Professor Francis T.K. Au
Professor and Head, Department of Civil Engineering
The University of Hong Kong

Opinion

3. Opening Up Strategy for Assessment of EWL Slab and NSL Slab

Figure 6.4.3.3.1 A typical slab-wall joint (from Detail 1 of [J6/4071])

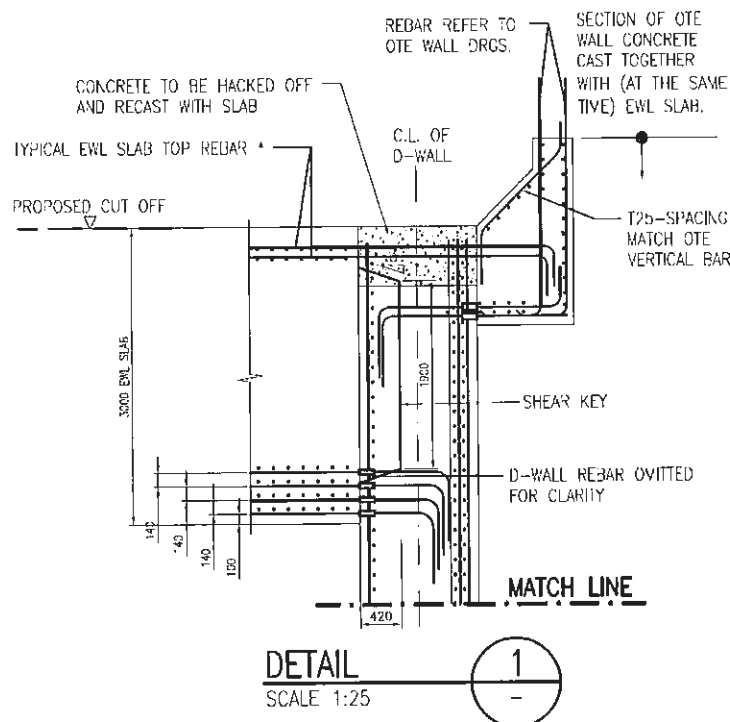
6.4.3.3 Recently, Atkins has submitted design calculations about the performance of the revised slab-wall joint details (Atkins's Report) [J6/4557-J6/4562]. In Atkins's Report, only some calculations for a typical slab-wall joint are provided, it is certainly not enough. Calculations must be carried out on all design variations of slab-wall joint to ensure their safety. There are a lot of problems in the calculations in Atkins's Report. In view of the large number of variations of slab-wall joint details, a typical detail shown schematically in Figure 6.4.3.3.1 is used for discussion.

Figure 6.4.3.5.1 Assumption of additional shear key in slab-wall joint [J6/4559]

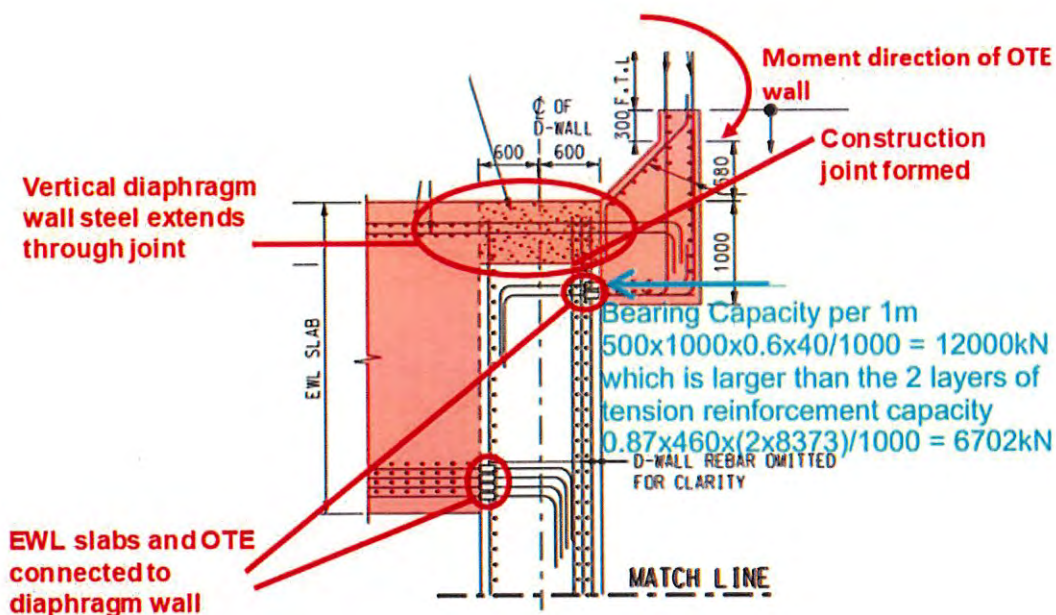
- 6.4.3.5 In the lower half of page 3 of 5 of Atkins's Report [J6/4559], Atkins refers to a cross sectional diagram of the revised joint (which is reproduced in Figure 6.4.3.5.1 below) claiming that the pink down-stand part of OTE wall can act as a shear key to help resist the horizontal shear stress at the additional construction joint. However, no calculation has been provided by Atkins to substantiate this claim. It is noted that the bearing force between the diaphragm wall (shown in white) and the down-stand part of OTE wall (shown in pink) acts at an eccentricity on the new concrete cast at a later date to replace the concrete at the top of the diaphragm wall hacked away (shown in pink), thereby also creating a bending moment. Apparently, the top reinforcement has not been designed to resist the combined tension and bending moment. It is uncertain if the horizontal shear resistance at the additional construction joint and the bearing resistance at the down-stand can indeed act together but not fail progressively. It should be demonstrated by calculations and/or experiments.

Figure 6.4.3.7.1 A typical slab-wall joint

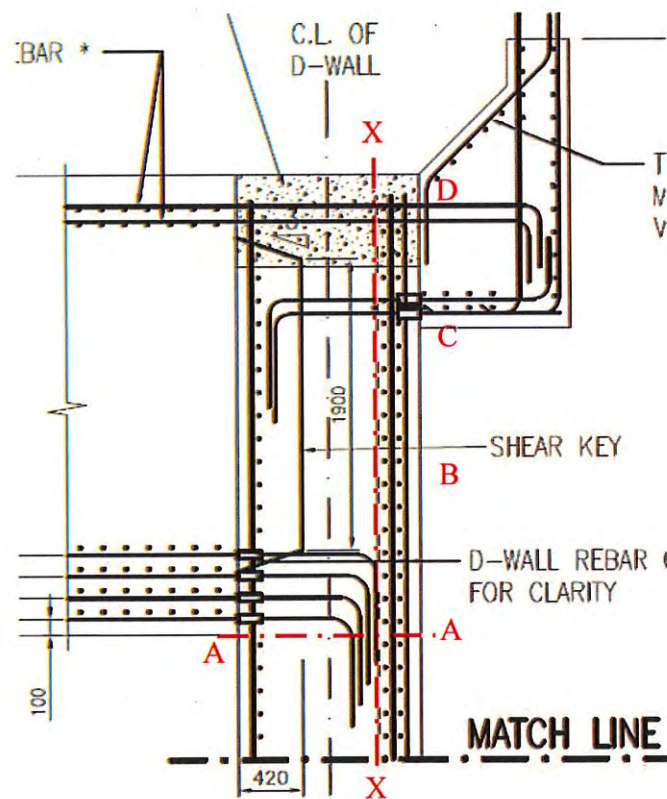
6.4.3.7 Figure 6.4.3.7.1 below shows the slab-wall joint enlarged for clarity. From the structural analysis, it is possible to identify certain critical bending moment, axial force and shear force at the bottom of slab-wall joint (i.e. Section A-A) at the ultimate limit state. Based on these internal forces, the designed tension taken by the group of reinforcement near the outer face of the diaphragm wall at level A can be determined. The forces taken by these reinforcing bars at level D should be virtually zero. Therefore Section X-X from level A to level D is a critical shear plane as the shear stresses there can be very high and they should be checked numerically. Similar design checks for various critical sections within the joint should be performed for each and every type of cross-sectional details adopted along the east diaphragm wall.
